Tierra Del Este Unit Eighty Two

City of El Paso — City Plan Commission — 10/18/2018

SUSU17-00047 — Resubdivision Preliminary

PROPOSED

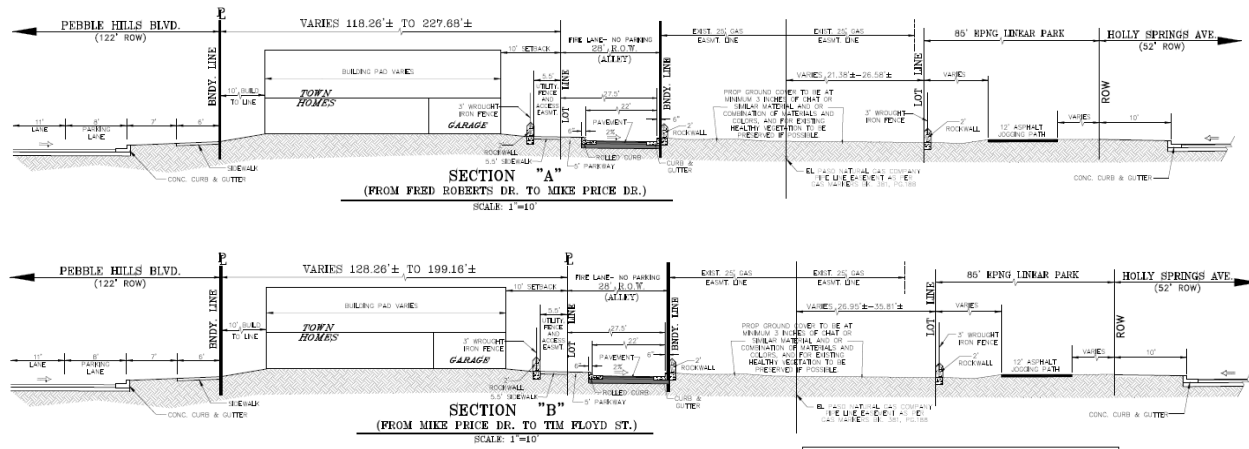
- To allow for an alternative design for the 28' alley which includes a 5' parkway and 22' of pavement.

ESD is good with the revised plat and alternative design that includes the 28' ROW (alley), and the abutting 5.5' utility easement. We also requested that signage be required in the alley per Title 12 indicating that the ROW is a fire lane/tow away zone.

We have reviewed the revised alley cross-section alternative design and have no further comments.

ATTACHMENT 2

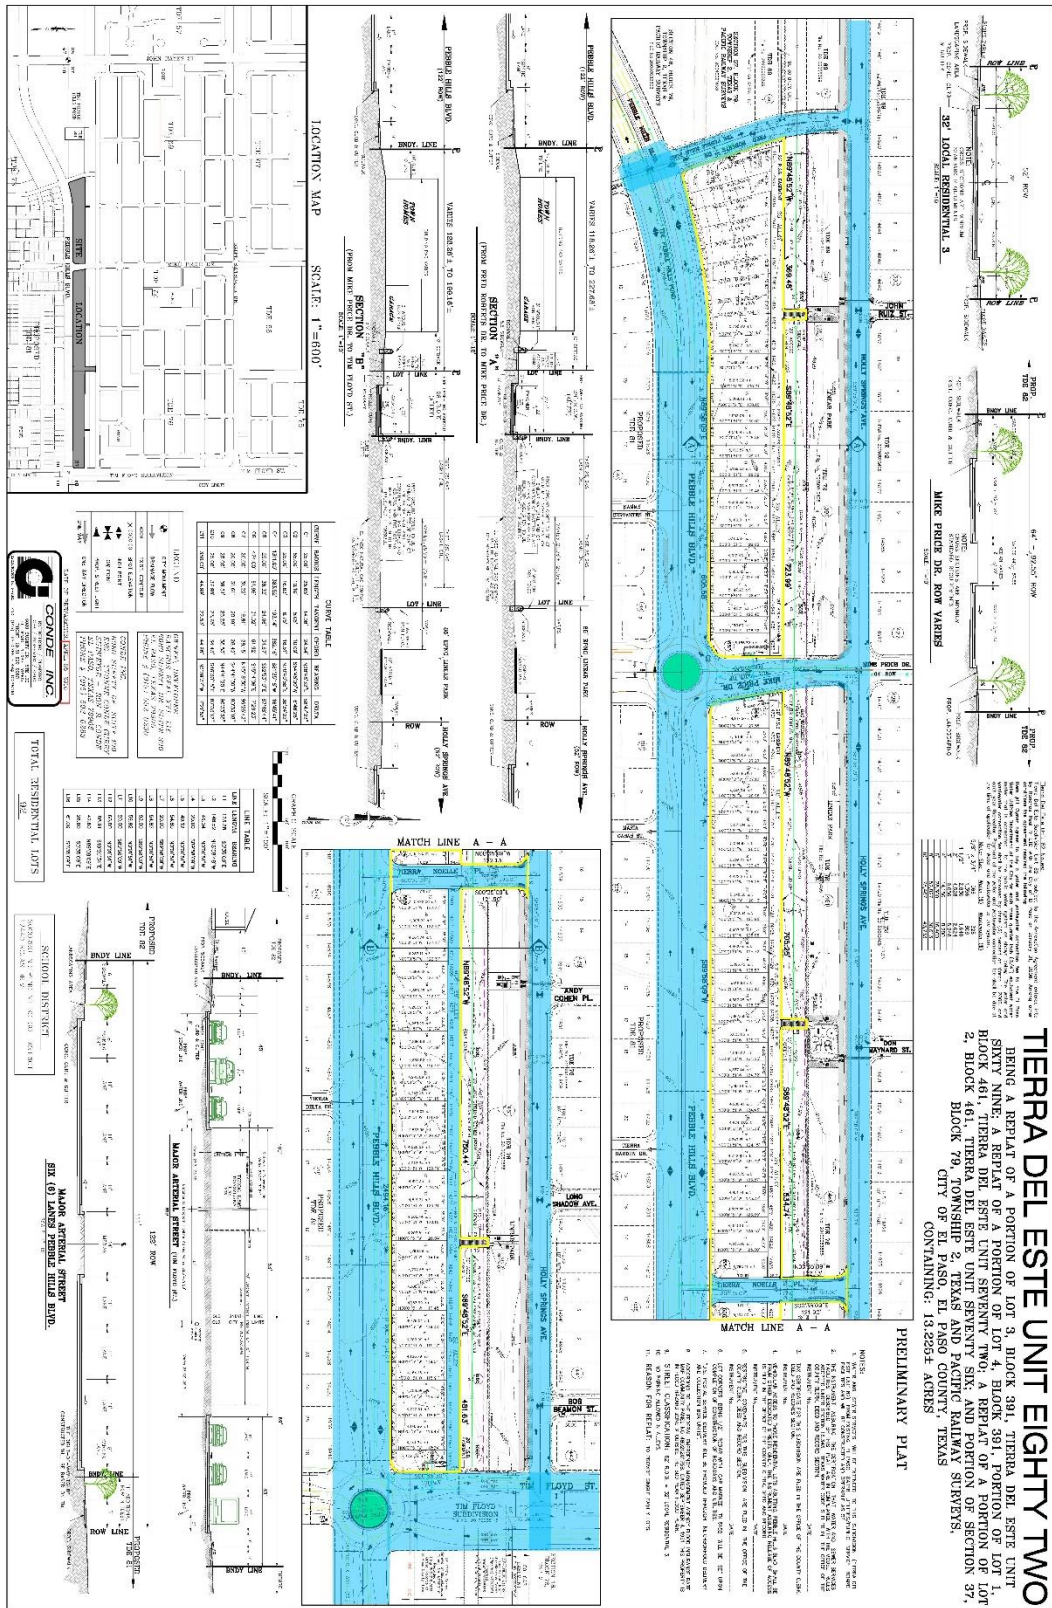
- Submit to the Planning & Inspections Department – Planning Division the following prior to recording of the subdivision:
 - a: Current certificate tax certificate(s)
 - b: Current proof of ownership.
 - c: Release of access document, if applicable.
 - d: Set of restrictive covenants, if applicable.
- Every subdivision shall provide for postal delivery service. The subdivider shall coordinate the installation and construction with the United States Postal Service in determining the type of delivery service for the proposed subdivision. In all cases, the type and location of delivery service shall be subject to the approval of the United States Postal Service.
- Verify and revise the date of preparation on the preliminary plat.

1. As per Tierra Del Este Unit 69, 72, & 76 Drainage Plans, the subject subdivision is to discharge into their proposed ponds; all downstream storm water management facilities should be in place prior to development of this development.
2. Show the drainage flow pattern within the alleys.
3. Show and label designated ponding destination(s).

The existing stub-outs are available for main extensions. The easements to accommodate the extensions are to be labeled PSB Easements instead of Utility Easements. A rock wall shall be constructed at the easement line that is within the lot.
